TRAILS AT ASPEN RIDGE FILING NO. 2

FINAL GRADING & EROSION CONTROL PLANS

NOVEMBER, 2019

| TRAILS AT ASPEN RIDGE | | | |
|---------------------------------------|---------------|----------------------------|-------------------|
| GRADING & EROSION CONTROL PLAN | | | |

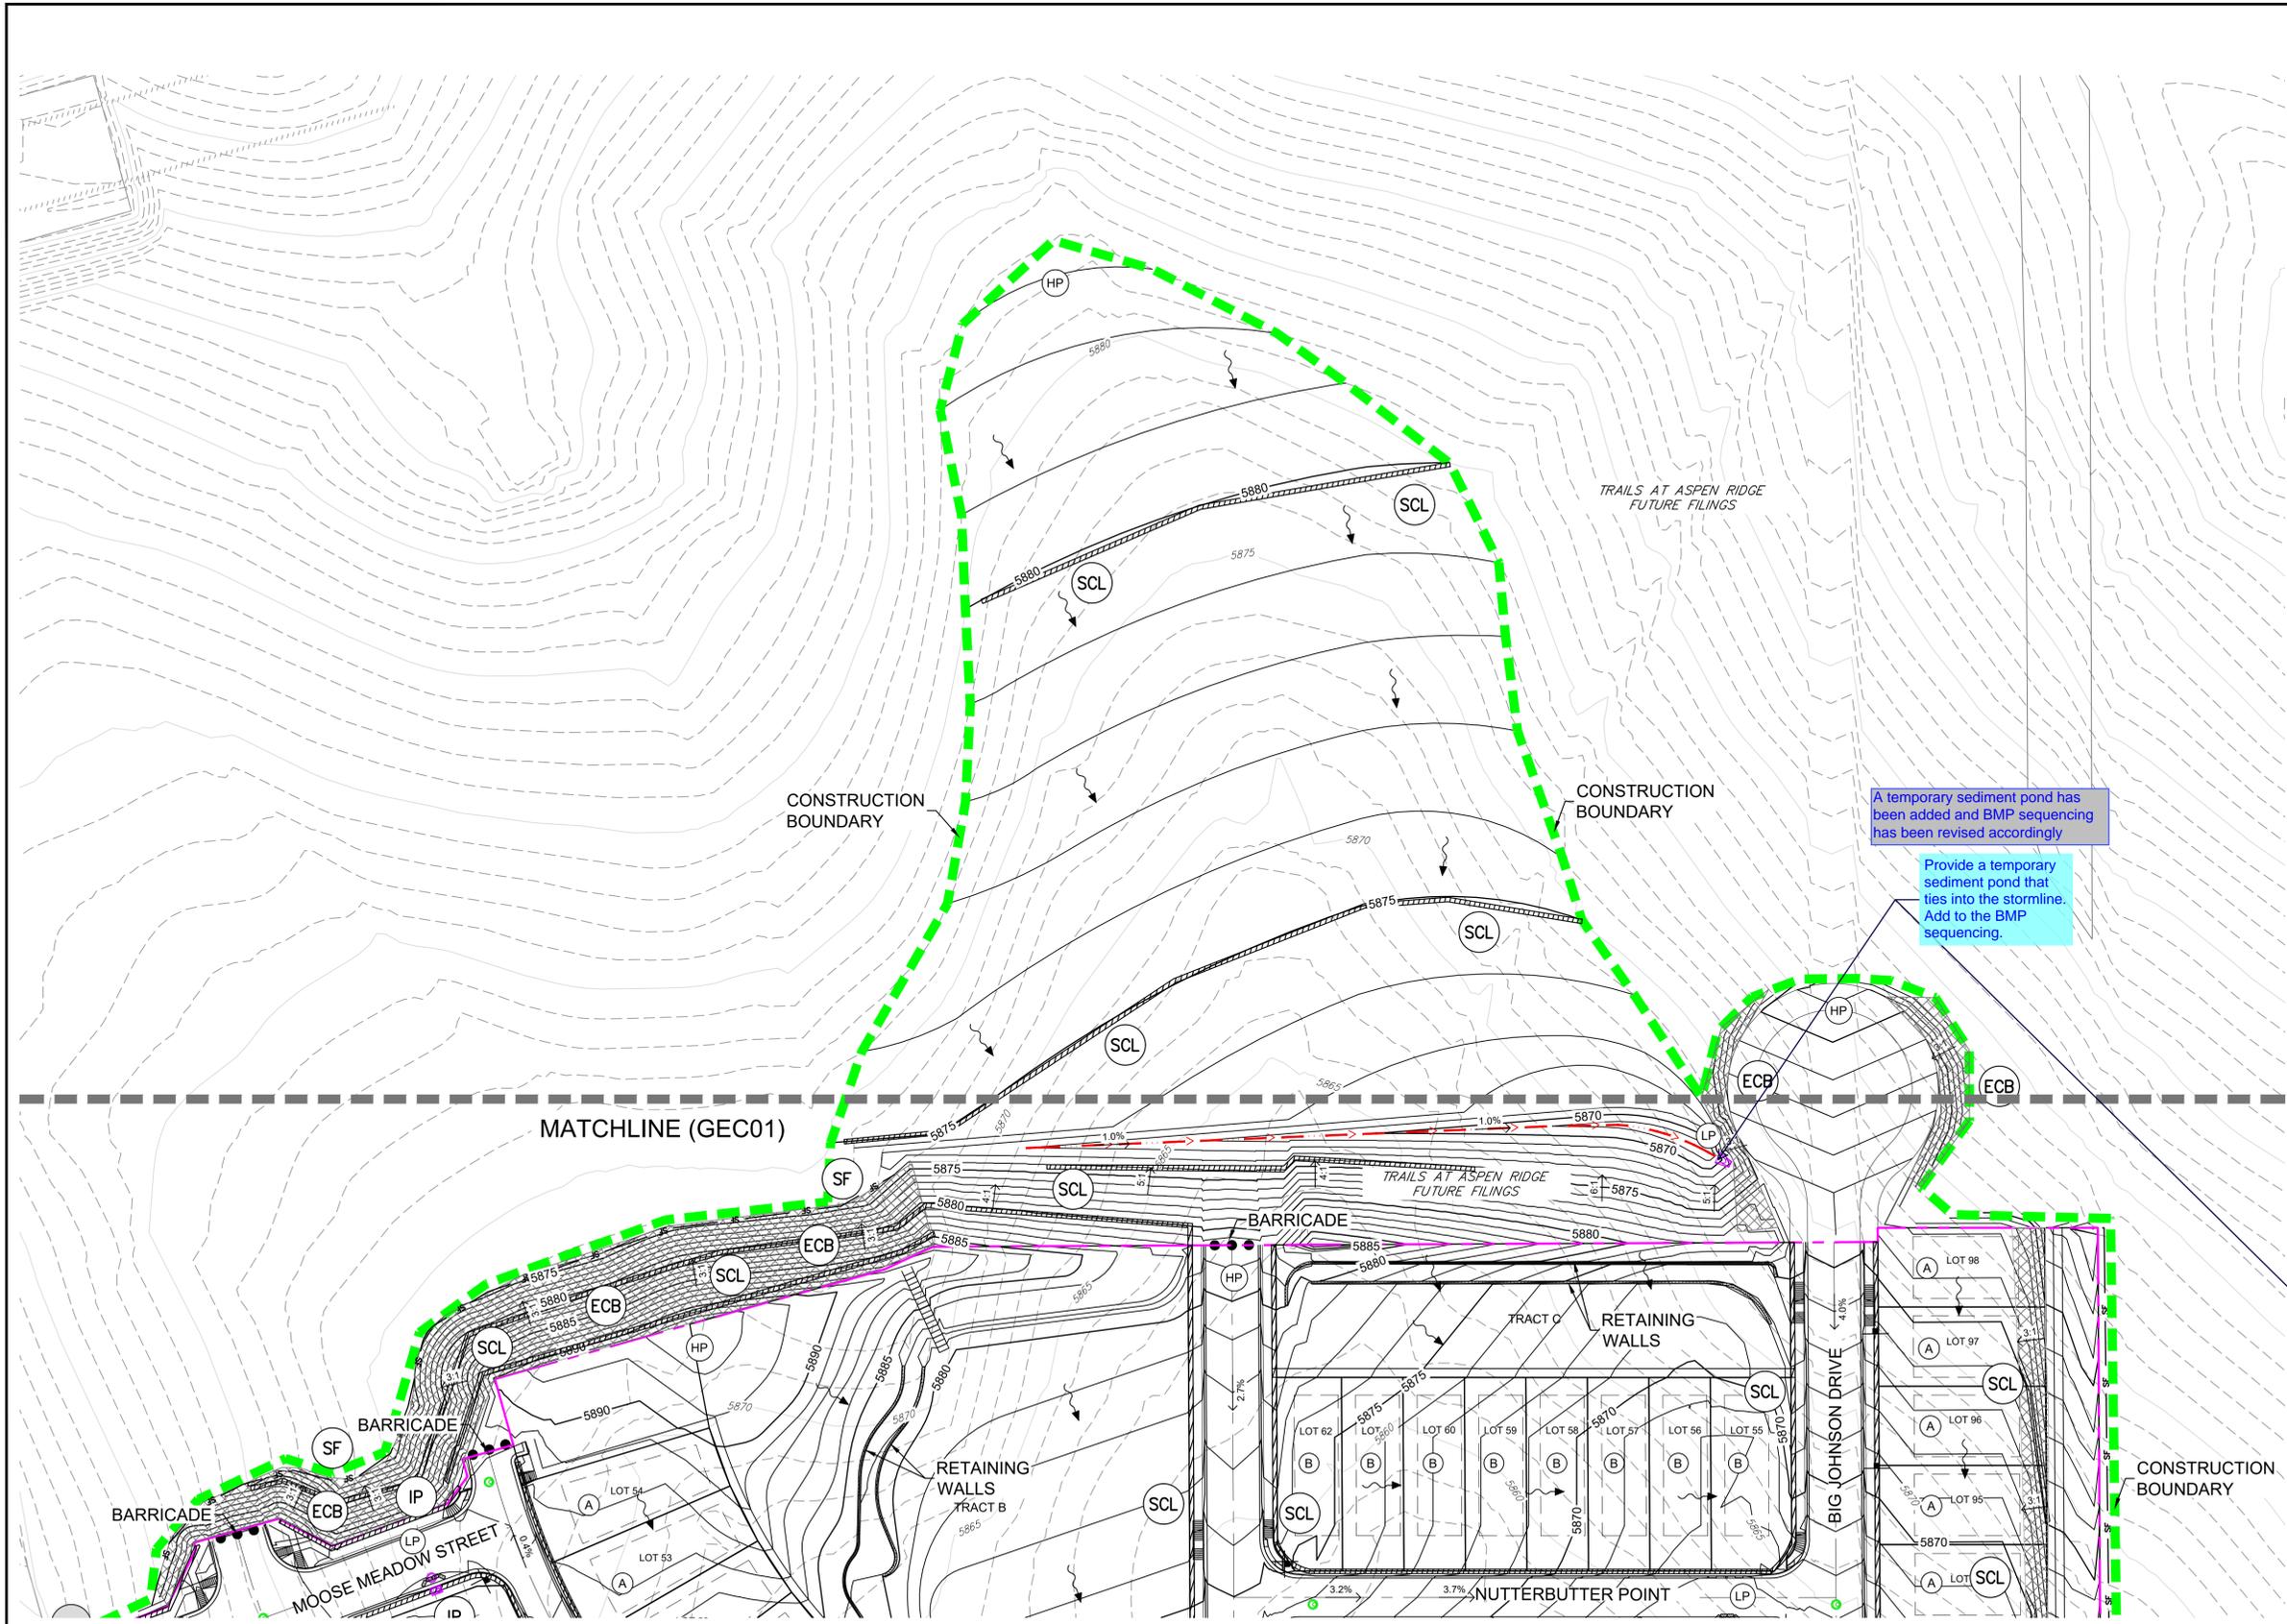
Provide a temporary sediment pond that ties into the stormline. Add to the BMP sequencing.

A temporary sediment pond has been added and BMP sequencing has been revised accordingly
